MEMORANDUM

Project 23146 – Medford Zoning Updates

Subject Planning and Permitting Committee Meeting 2

Hydrography

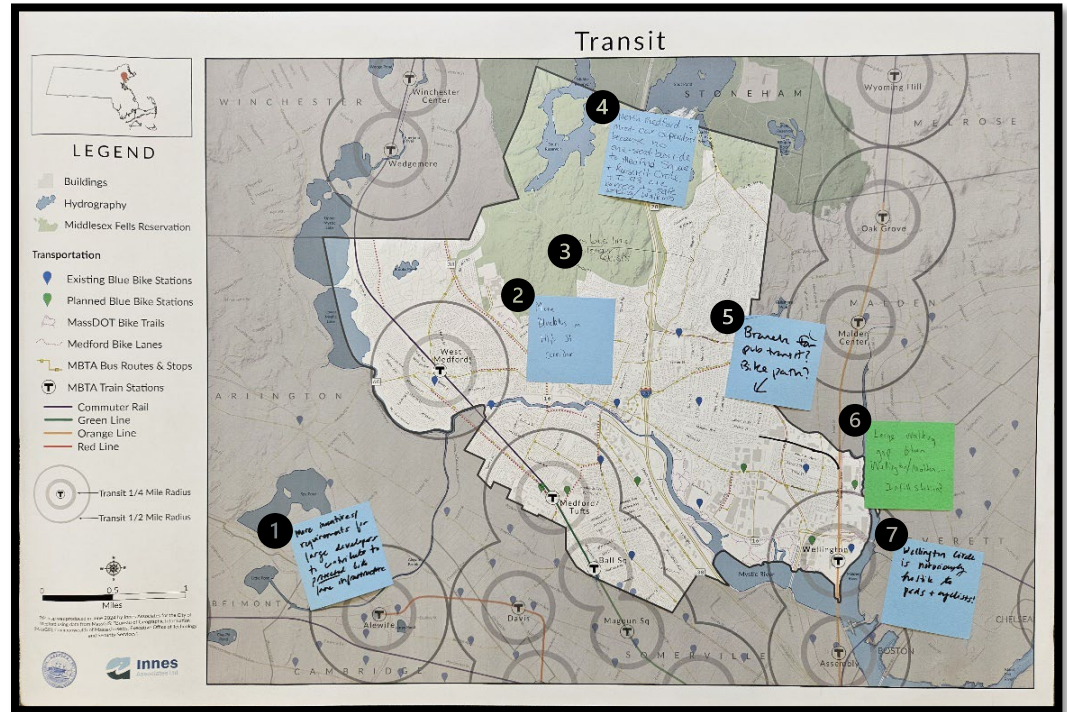
1. Are there any areas of undetermined floodway?
2. What is best practice for building regs in flood plain areas – can we update to ensure new builds are more flood resilient?

Transit

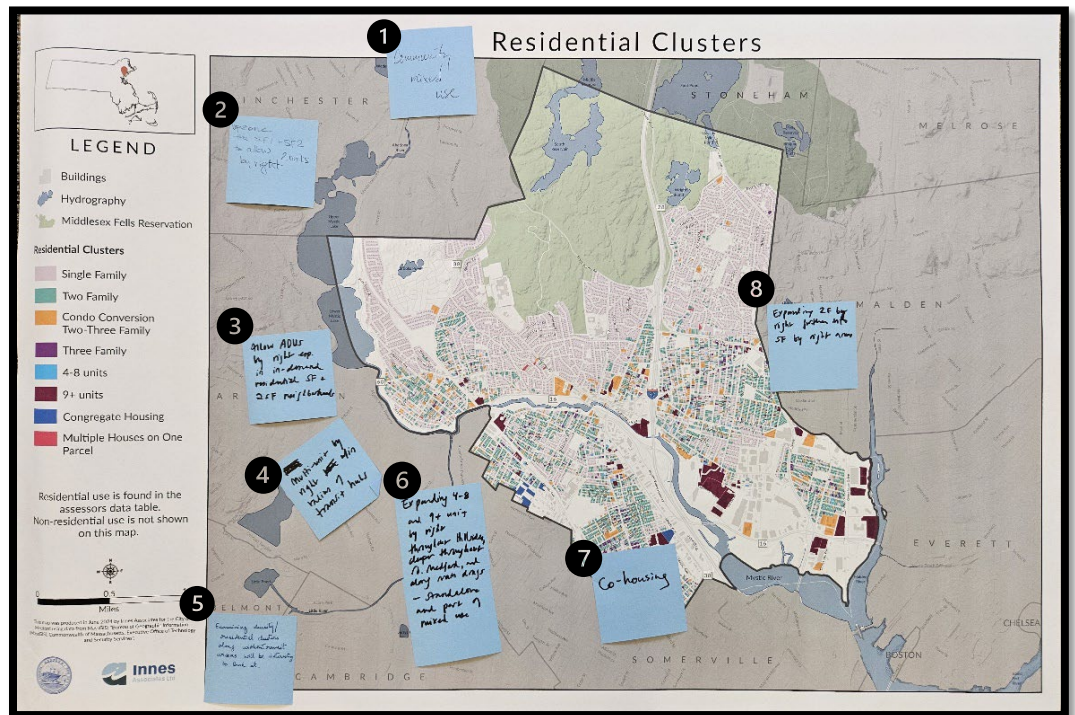
1. More initiatives/requirements for large developers to contribute to protected bike lane infrastructure.
2. More blue bikes on High St Corridor.
3. This bus line no longer exists.
4. North Medford is most car dependent because no one-seat bus ride to Medford Square + Roosevelt Circle + I-93 are barriers to safe biking/walking.
5. Branch for public transit? Bike path?
6. Large walking gap between Wellington/Malden... Infill Station?
7. Wellington Circle is notoriously hostile to peds + cyclists!

Residential Clusters

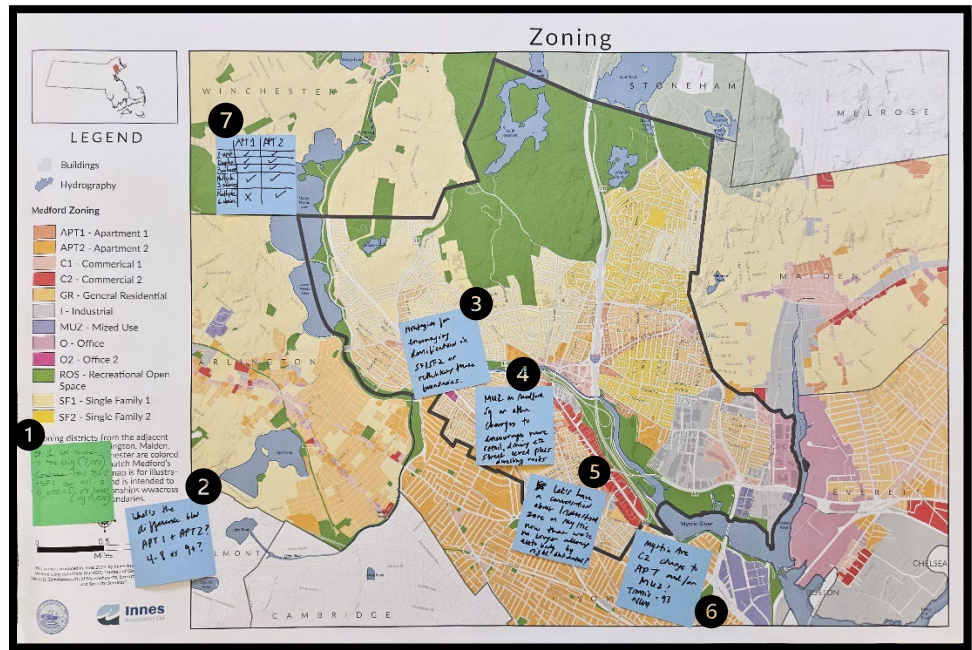
1. Community mixed use.
2. Upzone the SF1 + SF2 to allow 2 units by right.
3. Allow ADUs by right esp. in in-demand residential SF + 2SF neighborhoods.
4. Multi-unit by right min radius of transit + hubs.
5. Examining density/residential clusters along with the Transit areas will be interesting to look at.
6. Expanding 4-8 and 9+ unit by right throughout Hillside, deeper throughout So. Medford, and along (illegible) – standalone and part of mixed use.
7. Co-housing.
8. Expanding 2F by right further into SF by right area.

Zoning

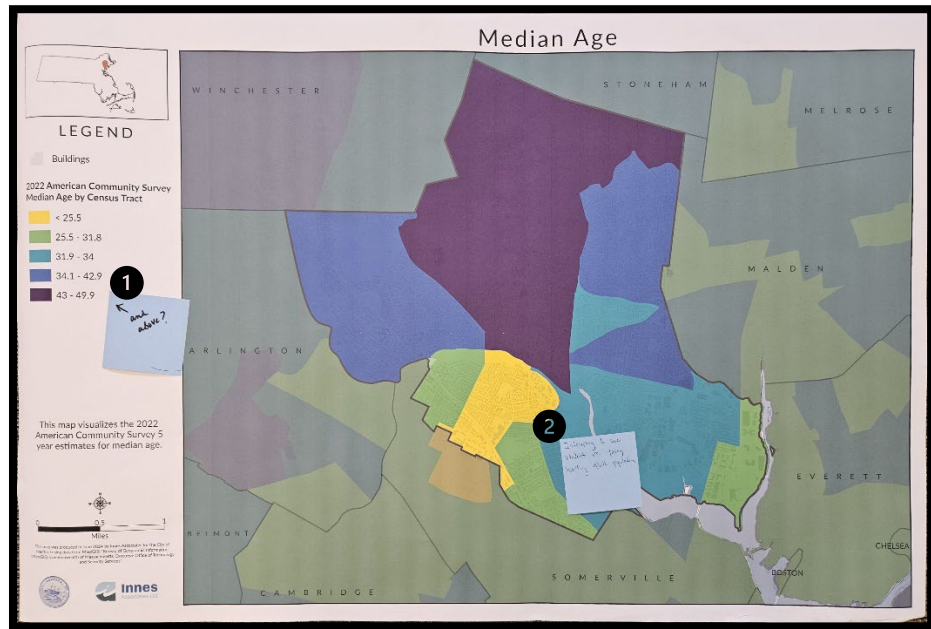
1. SF-1 lot size is too big (7,000). Combine the SF2 + SF1 so all is 5,000 sf or lower (e.g. 4,000).
2. What's the difference btw APT1 + APT2? 4-8 vs 9+?
3. Strategies for encouraging indemnification? In SF/SF2 or rethinking those boundaries.
4. MUZ in Medford Sq or other changes to encourage more retail, dinery etc. Street area plus dwelling units.
5. Let's have a conversation about Industrial Zone on Mystic now that we're no longer allowing auto body by right. Outdated?
6. Mystic Ave C2 change to APT and/or MUZ! Transit (illegible) – 93.
7. Table:

Median Age

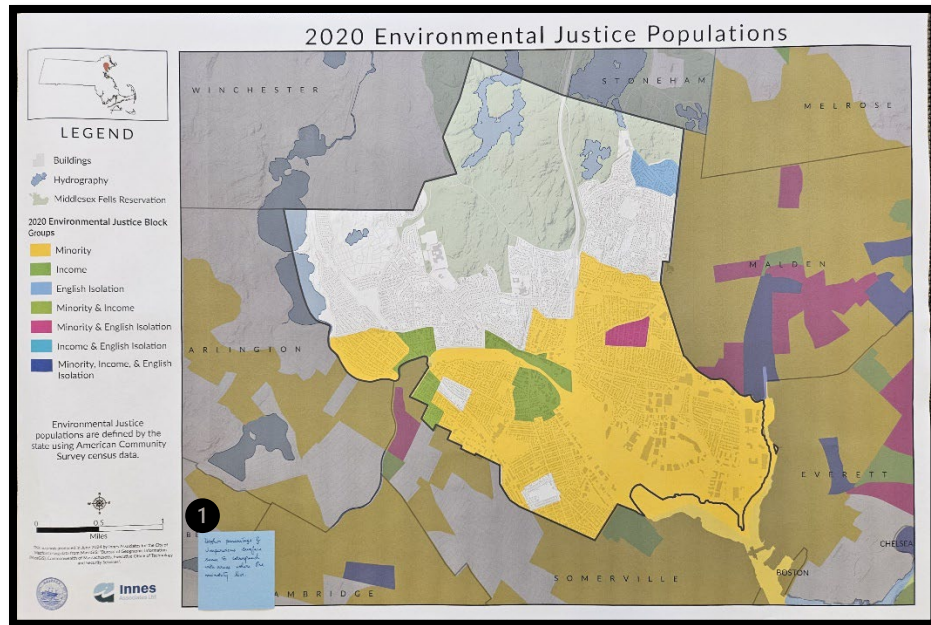
1. (As a response to 43-49.9 median age) ↑ and above?
2. Interesting to see students vs. young working adult population.

2020 Environmental Justice Populations

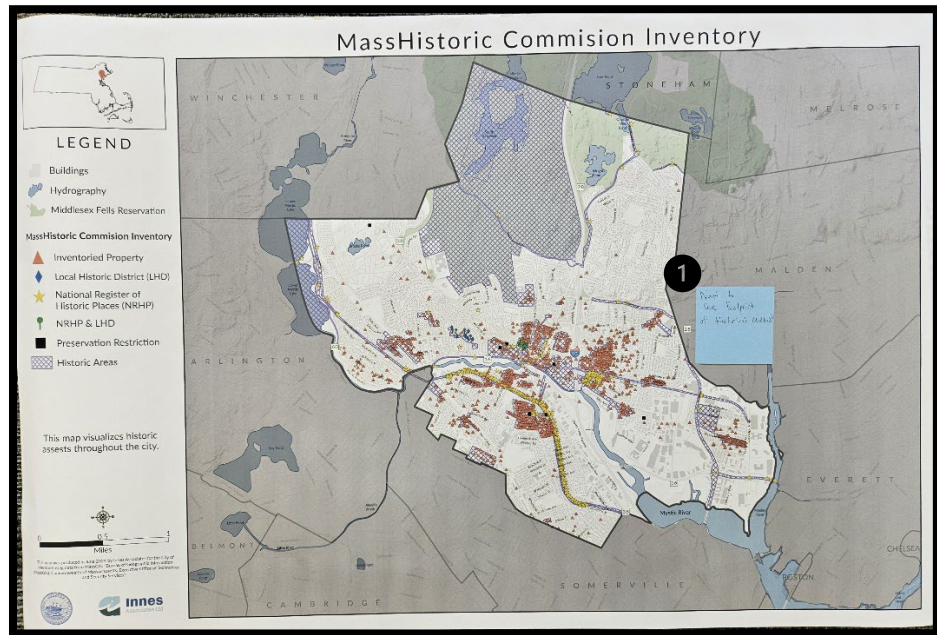
1. Higher percentage of impervious surface seem to correspond with areas where the minority live.

MassHistoric Commission Inventory

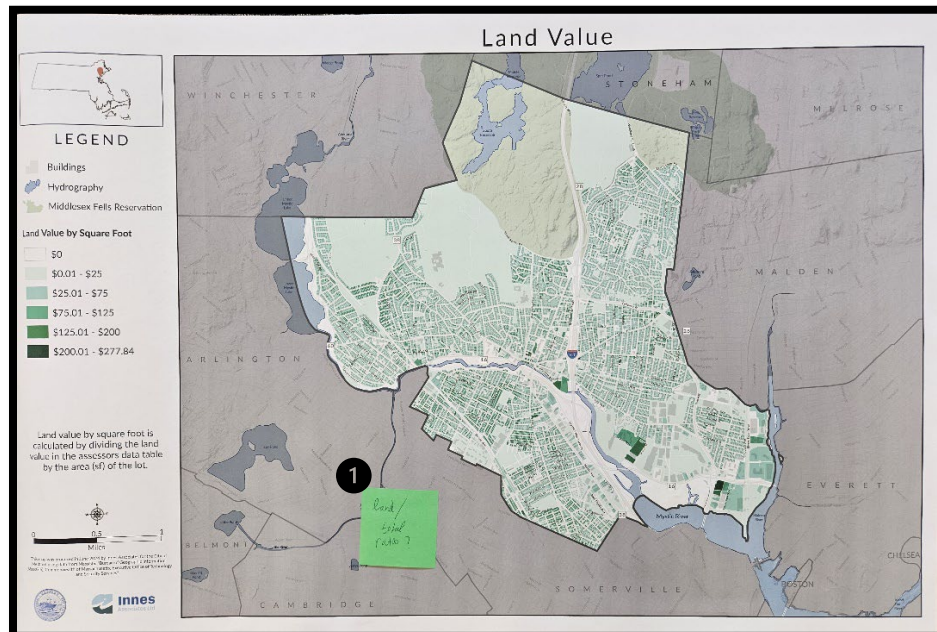
1. Neat to see footprint of Historical Medford!

Land Value by Square Foot

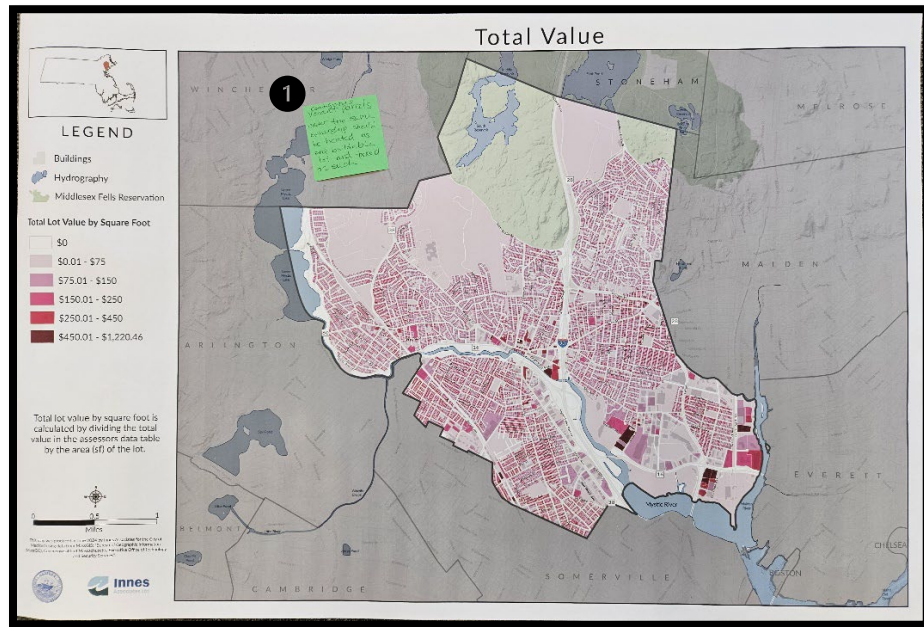
1. Land/Total ratio?

Total Value by Square Foot

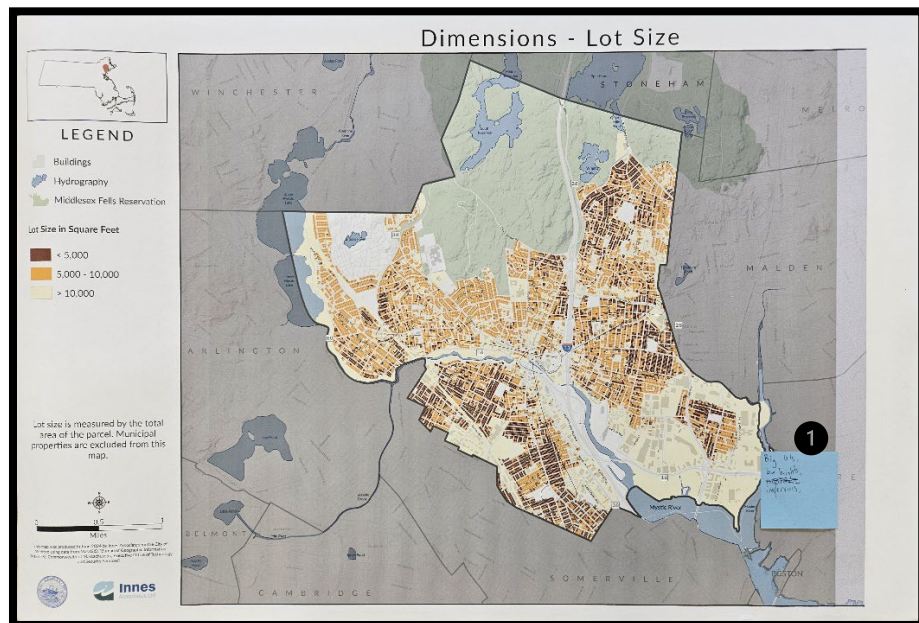
1. Contiguous vacant parcels under the same ownership should be treated as one buildable lot and taxed as such.

Lot Size in Square Feet

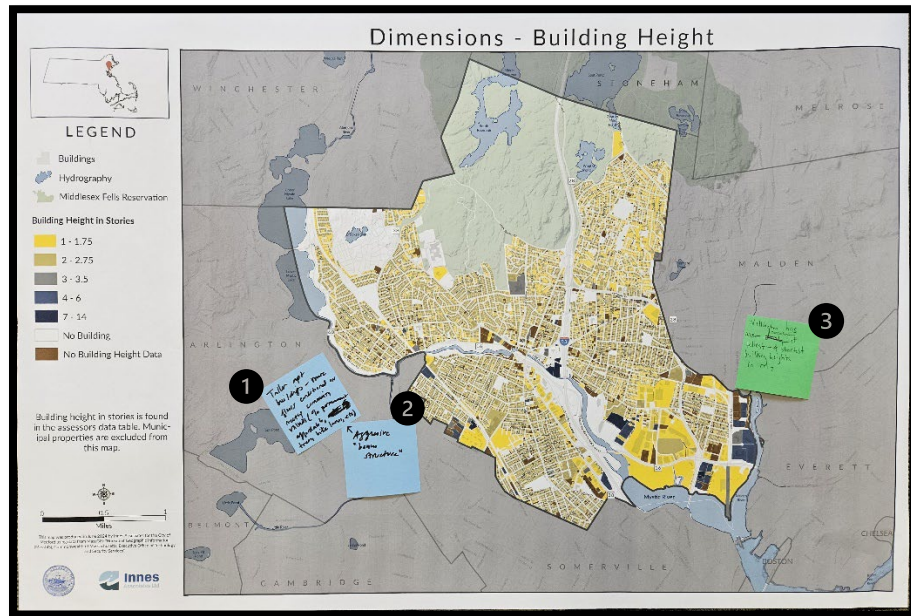
1. Big lots. Low heights. Impervious.

Building Height in Stories

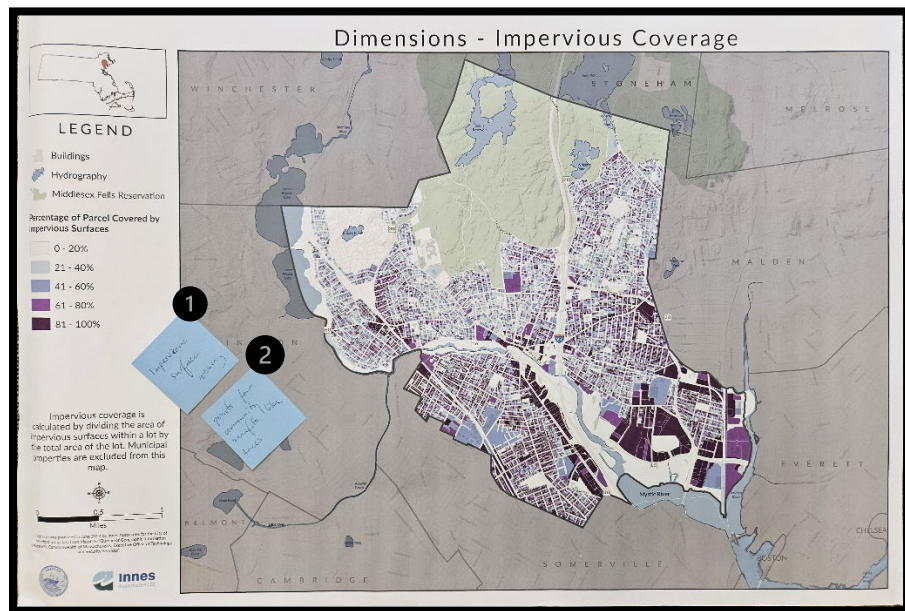
1. Taller apt buildings – more floors conditional on meeting community values (% permanent, affordable, tram, bike lanes, etc.)
2. ↑ Aggressive “bonus structure”.
3. Wellington has most concentration of tallest – shortest building heights in City.

Percentage of Parcel Covered by Impervious Surfaces

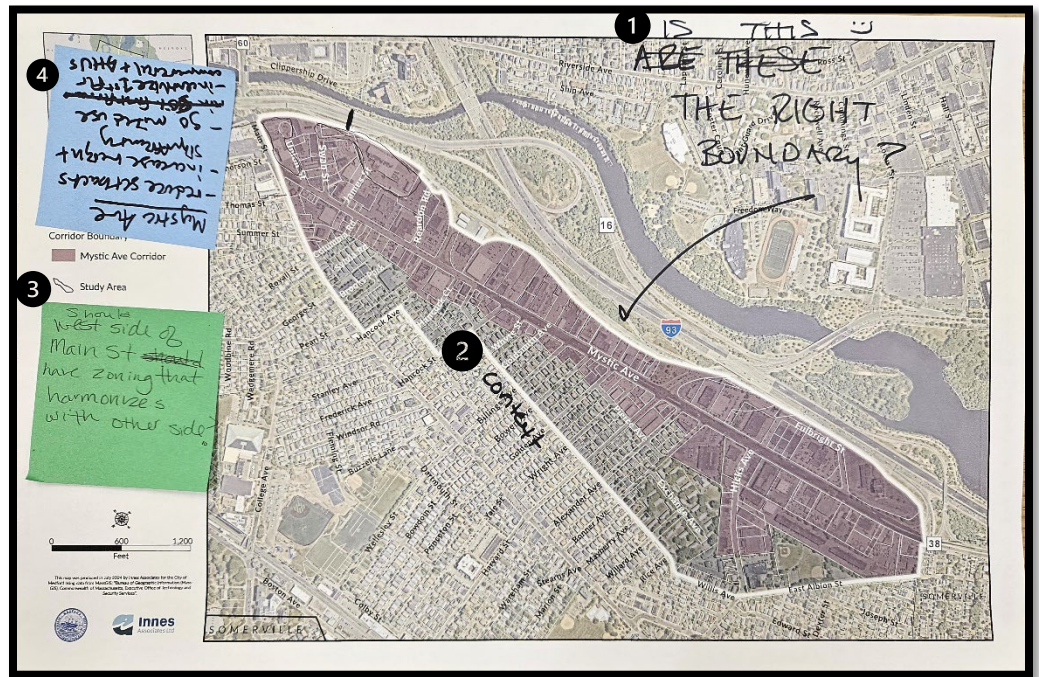
1. Impervious surfaces zoning.
2. Point for community benefits like trees.

Study Area

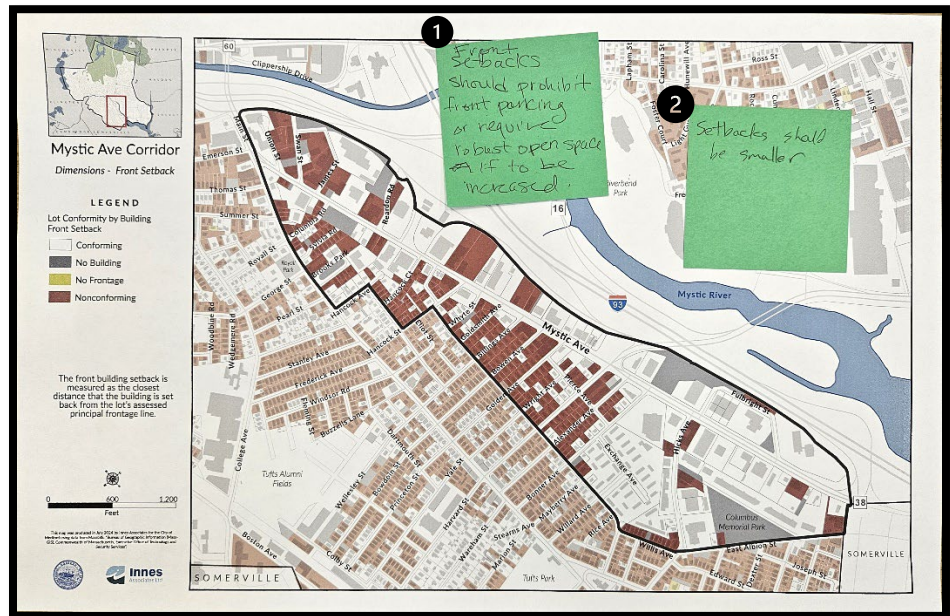
1. Is this the right boundary?
2. Context.
3. Should West Side of Main St have zoning that harmonizes with other side?
4. Mystic Ave:
 - reduce setbacks
 - increase height significantly
 - go mixed use
 - incentivize 1st floor commercial + AHUs

Front Setback

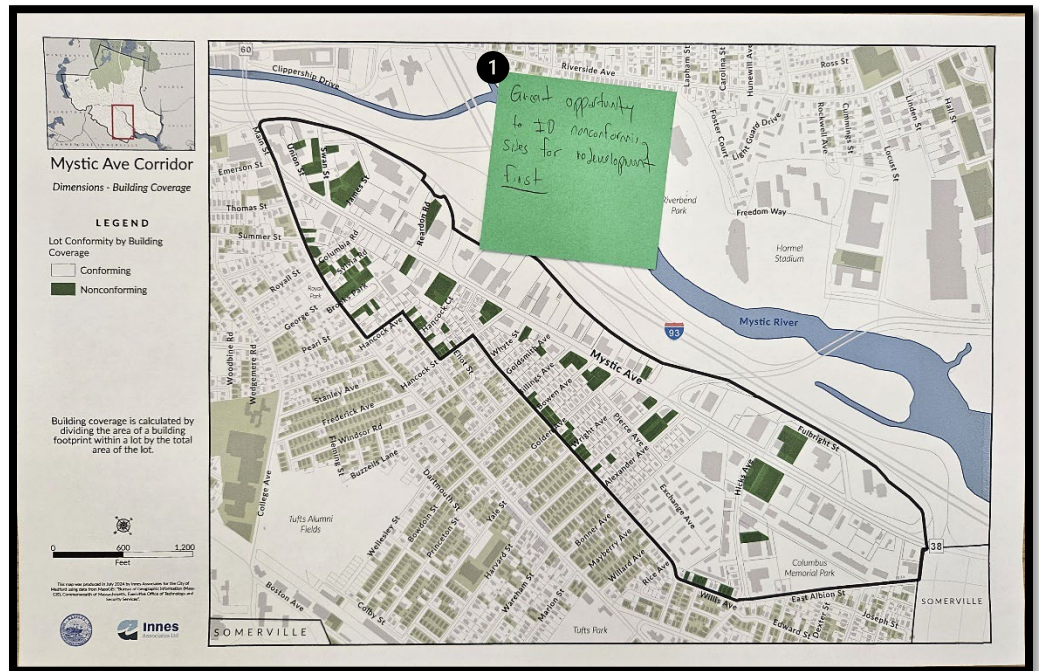
1. Front setbacks should prohibit front parking or require robust open space if to be increased.
2. Setbacks should be smaller.

Building Coverage

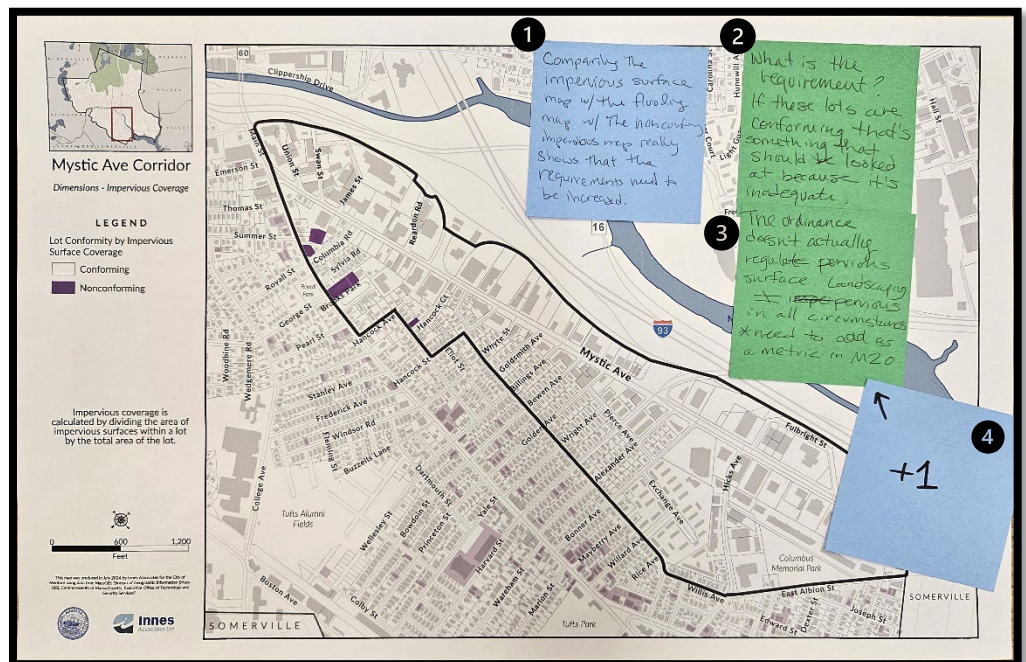
1. Great opportunity to ID nonconforming sites for redevelopment first.

Impervious Coverage

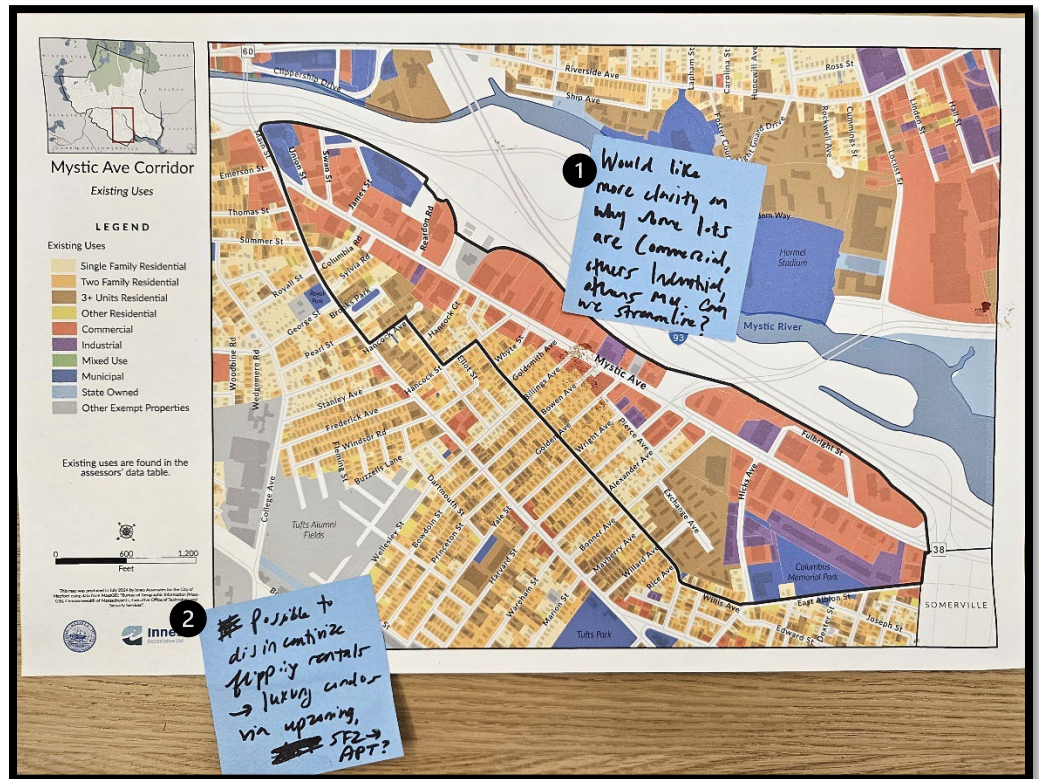
1. Comparing the impervious surface map with the flooding map with the nonconformity impervious map really shows that the requirements need to be increased.
2. What is the requirement? If these lots are conforming that's something that should be looked at because it's inadequate.
3. The ordinance doesn't actually regulate pervious surface. Landscaping ≠ pervious in all circumstances. *Need to add as a metric in MZO.
4. ↑ +1
